### THM 4T60-E 4TH CLUTCH CHANGES FOR 1993

Figure 1

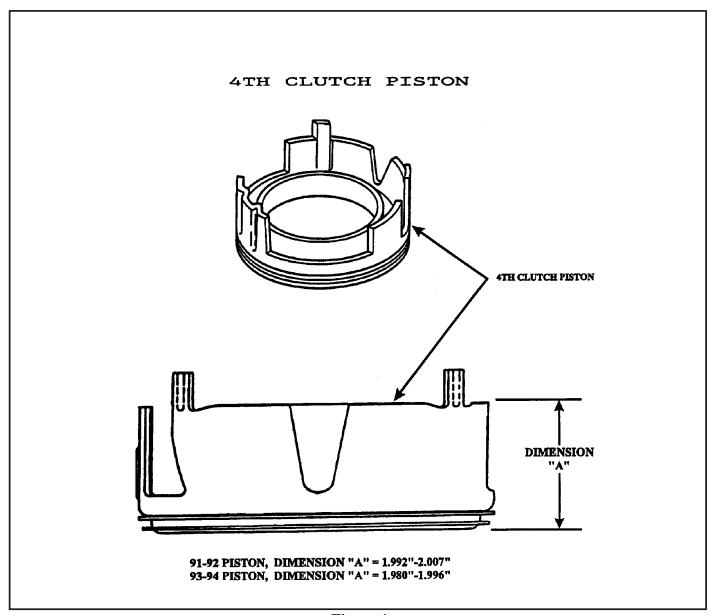
- (1) **4TH CLUTCH PISTON** Height of the piston apply legs, as measured in Figure 1, has changed slightly on both minimum and maximum tolerances.
- **(2) 4TH CLUTCH APPLY PLATE** Changed to a "Flat" plate instead of the previous "Tapered" plate, and the thickness changed to .133" instead of the previous .163", as shown in Figure 2. There are now two of these .133' thick plates used in the 4th clutch stack-up, as shown in Figure 2.

Figure 2

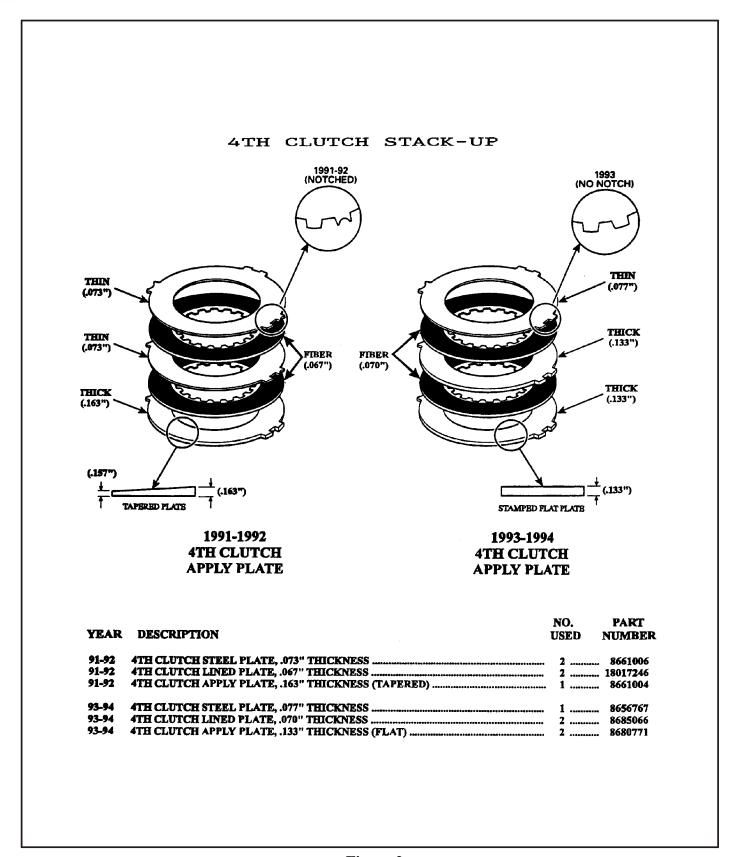
- (3) 4TH CLUTCH STEEL PLATES Thickness was increased to .077" instead of the previous .073", and the "Notch" was removed from the tab for I.D. as shown in Figure 2. The new 4th clutch stack now uses only one of these plates and is the same thickness and part number as the early 440-T4 steel plate (See Figure 2).

- (4) 4TH CLUTCH FIBER PLATES Very minimal thickness change as shown Figure 2.
- **(5) CHANNEL PLATE** The depth in the 4th clutch area, as measured from the gasket surface to the 4th clutch surface, was increased to .792' instead of the previous .772' to accommodate the revised 4th clutch stack-up (See Figure 2). This distance MUST be measured with a depth micrometer for accuracy.

- (1) The 4th Clutch Piston will interchange in all models without problems as the piston heights all still measure within .003" of one another.
- (2) The 4th Clutch Fiber Plates will interchange in all models as the thick-ness change was only .003".
- (3) The 91-92 Steel Plate stack-up MUST be used with the 91-92 Channel Plate. If the 91-92 Steel Plate stack-ups used with the 93-94 Channel Plate, the clutch clearance measures .086" (TOO LOOSE).
- (4) The 93-94 Steel Plate stack-up MUST be used with the 93-94 Channel Plate. If the 93-94 Steel Plate stack-up is used with the 91-92 Channel Plate, the clutch clearance measures .025' (TOO TIGHT).

#### CHANNEL PLATE

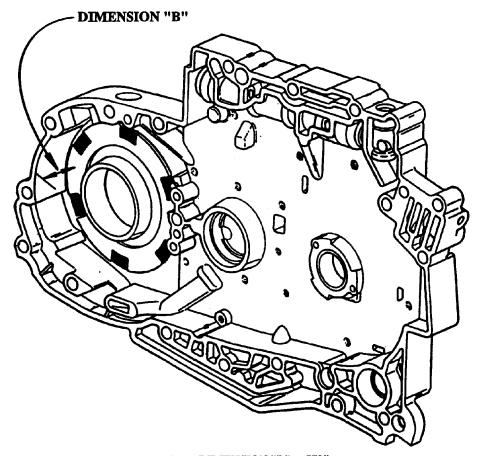
91-92 CHANNEL PLATE, DIMENSION "B" = .772" 93-94 CHANNEL PLATE, DIMENSION "B" = .792"

THIS DIMENSION SHOULD BE MEASURED FROM THE GASKET SURFACE TO 4TH CLUTCH SURFACE, WITH A DEPTH MICROMETER, AS SHOWN.
